UNITED STATES PATENT AND TRADEMARK OFFICE

| 09/883,851 | 06/18/2001 | Bogdan C. Maglich | HIENER.1CPC1CP | 9955 |

| Office Action Summary | Application No. | Applicant(s) | |

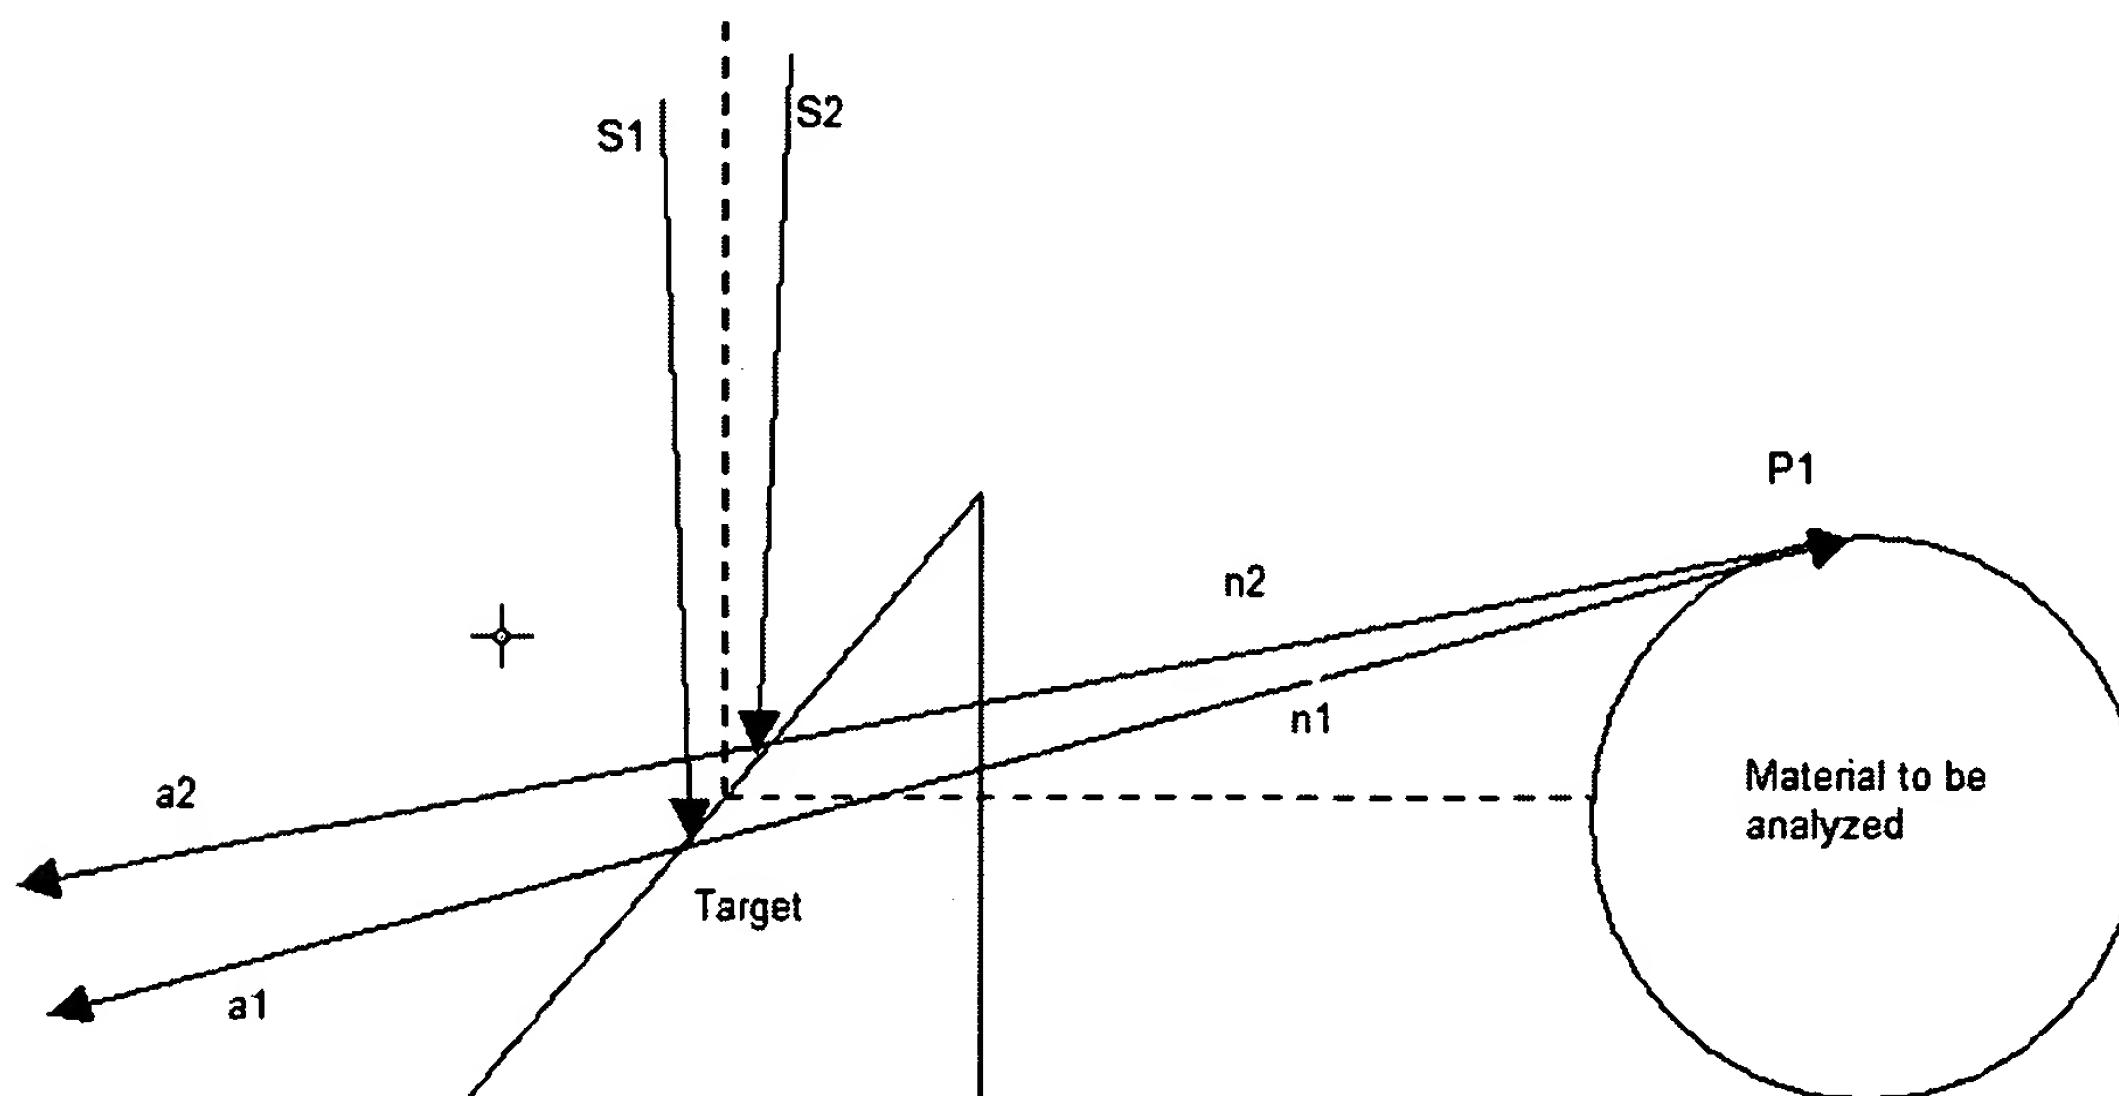
a. Page 25 of the specification as filed sets forth "In Figure 18 the object diamond 800 is drawn outside target box 835 for clarity; in practice, it is placed inside target box 835..." It is not seen how in fact this is possible because the APSTNG is a SEALED tube neutron generator that contains Deuterium gas. It is not seen wherein Applicant has set forth a manner in which to load material to be analyzed in the target of the APSTNG. Further, it is not seen wherein either the specification or the drawings set forth how such is possible.

b. Claims 1 and 5 set forth that the material to be analyzed is closer to the target material than the particle detector array that deciphers the alpha emissions coordinates, however applicant has failed to set forth how and in what manner imaging may be possible at all. Applicant states (see page 25 of the specification) that the material to be analyzed is placed in the target box with a distance of .3cm, i.e. 3mm however the specification is silent as to how such is possible. It is the examiners contention that such is indeed NOT possible nor feasible. For example, it is impractical to locate a material to be analyzed that close to the target material because if said material is not within the APSTNG then it stands to reason that the walls of the APSTNG are at least that close to the target material. This does not appear possible due to the potential of voltage breakdown between electrode structures and the walls of the tube. That is, the

electrode and voltage requirements necessary to encourage the D-T reaction to produce neutrons put a lower limit on the tube dimensions. See section 4.1.1 The STNG tube of the Bechtel reference and section 2.1 of the Hurley reference.

Support for the Examiners contentions may be had in the following discussion of the above representation of the target and material to be analyzed which is an enlargement of figure 18 of the instant application.

One can see that the paths of two candidate source particles S1 and S2 are shown impinging on the target. S1 is representative of the left most edge of the nominal source beam, that is, the left most side of the smallest beam capable of being directed at the target. S2 is representative of the rightmost edge. The distance between S1 and S2 is about 0.7mm. The neutron source is not a point source, but an extended source. This is so that repeated bombardment of the exact same spot doesn't deplete the tritiated target. Such bombardment would reduce the functional lifetime to an unusable extent. This is considered as being supported by applicant's own disclosure. For example, Figure 6 of applicant's disclosure shows the alpha and neutron beam diverging. If the beam causing the reaction were a point source, then it would stand to reason that the beam emitted therefrom would not diverge.

Elementary optics teaches that a target placed so close to an extended source does not produce a clear image. That is why the iris of a camera must be closed tightly (and the exposure lengthened) for close up pictures while the iris must be opened (and the exposure shortened) to take panoramic pictures of mountains in the distance. This phenomenon is true regardless of whether the image plane (in this case the alpha detector) is 115cm (as set forth in the spec) or 11.5cm. The only difference in these two distances would be the size of the

The inherent fuzziness to which the Examiner has explained can be visualized by resorting to the representation above. S1 results in the production of neutron n1 and a corresponding alpha particle a1. The same is true for S2, n2 and a2. In this representation both n1 and n2 impinge upon the same point of the material to be imaged while their corresponding alpha particles would be detected at the surface of the alpha detector, which according to applicants specification is 115cm away. In this example, the same point P1 would be spread over 20cm at the image plane defined by the alpha detector, that is, at

115cm away, the inherent resolution is 20cm which is far to large to image defects as small as applicant asserts.

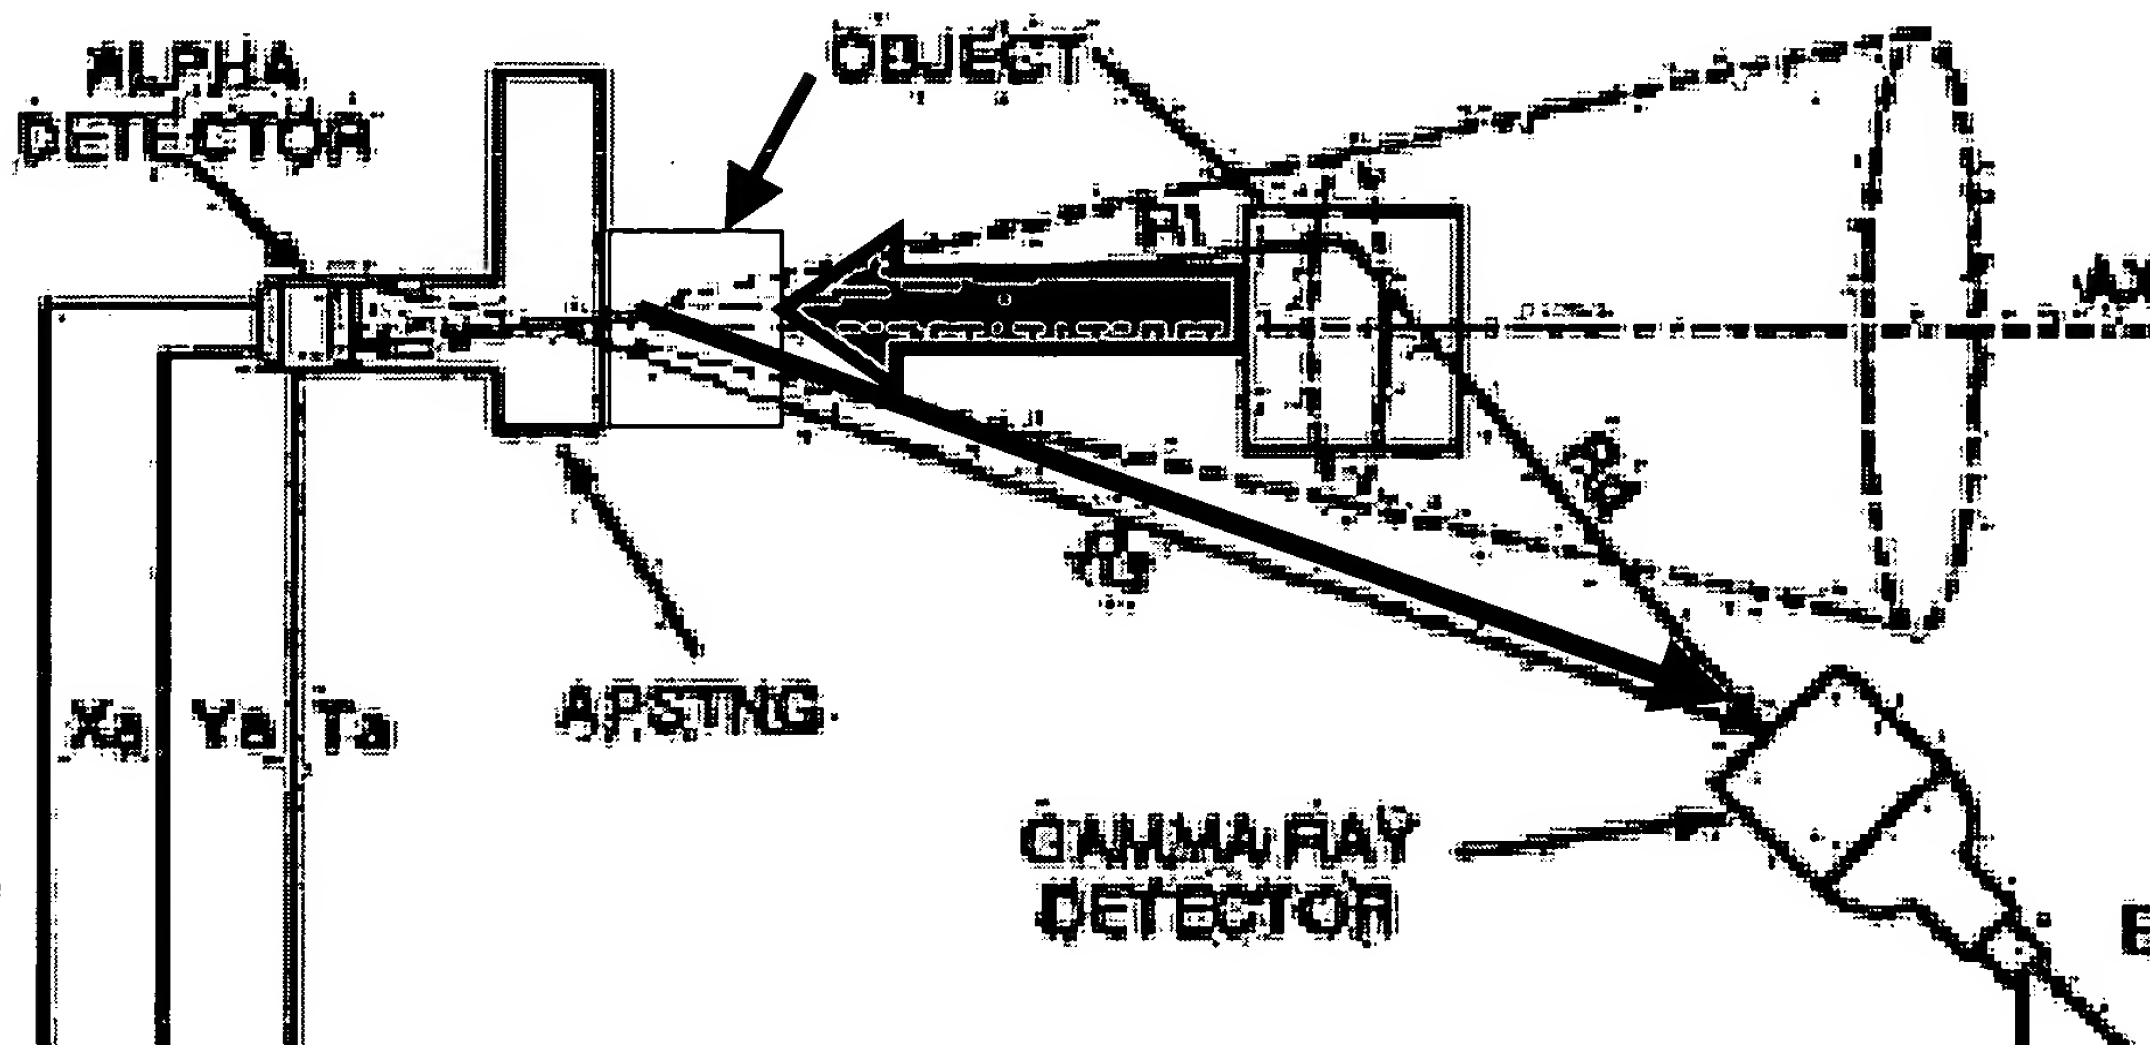
Again, the examiner has already addressed the issues of the distances and filtered electrical signals in section 19 above and incorporates said section 19 herein. Further as shown by the enlarged section of Figure 2 below, Rhodes is inherently capable of being used in the same manner claimed as applicant regarding the distances by merely moving the material to be analyzed closer to

the APSTNG. Again, this reference is inherently capable of being used in the manner set forth in the claim and the capability need only be present.
